United States Patent and Trademark Office

APPLICATION NO.	FILING DATE	FIRST NAMED INVENTOR	ATTORNEY DOCKET NO.	CONFIRMATION NO.
09/832,530	04/11/2001	Alain Dunand	33441	1249
7590 04/29/2004			EXAMINER	
PEARNE, GORDON, McCOY & GRANGER			TRAN, LY T	
526 Superior Avenue East, Suite 1200 CELVELAND, OH 44114-1484			ART UNIT	PAPER NUMBER
			2853

DETAILED ACTION

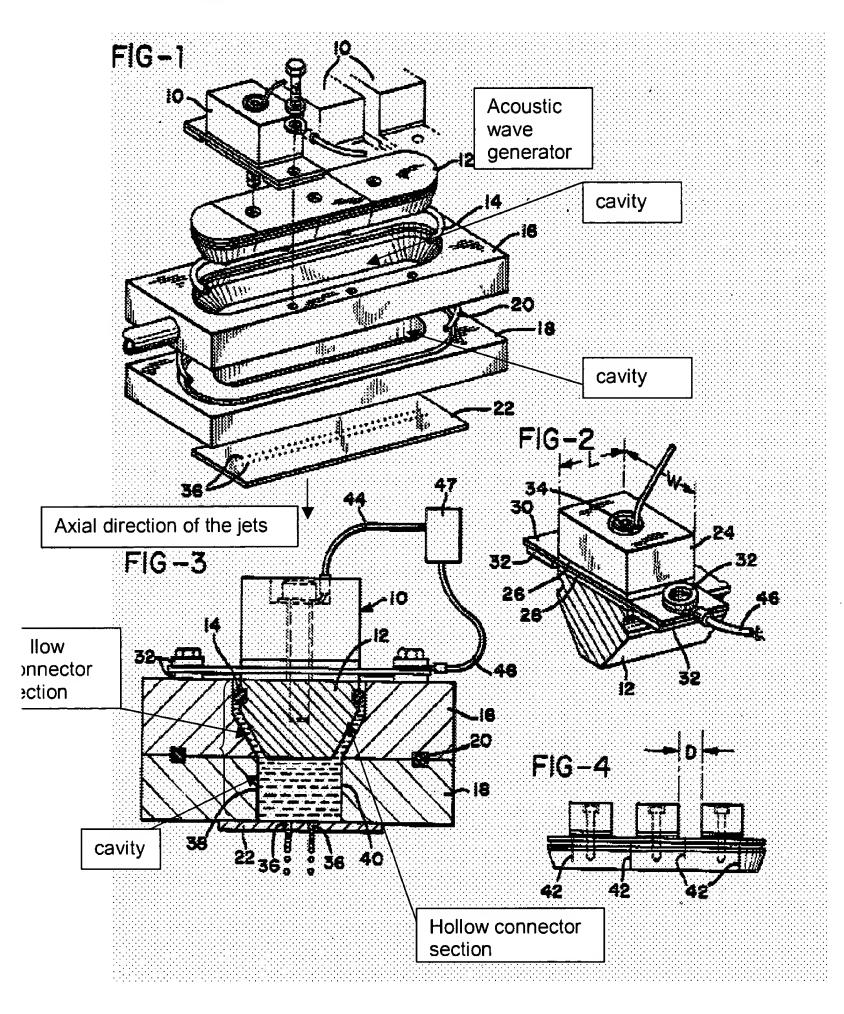
- The acoustic-wave generator housing (16) and the cavity being connected
 by a hollow connector section (see figure 3 below)

Applicant's argument that Cha does not teach the acoustic wave generator with a body elongated in an axial direction to the ink jet, each generator having a vibrating surface perpendicular the axial direction of the jets is not persuasive because figure 3 shows the acoustic wave generator is extending in direction along the axial direction of the ink jet and a vibrating surface perpendicular the axial direction of the jets. Even the figure 1 show the acoustic wave generator that is elongated in a direction perpendicular o the ink jets but figure 3 also shows the acoustic wave generator with a body elongated in an axial direction to the ink jet. Also, Cha teaches the acoustic-wave generator housing (16) and the cavity being connected by a hollow connector section (see figure 3 below).
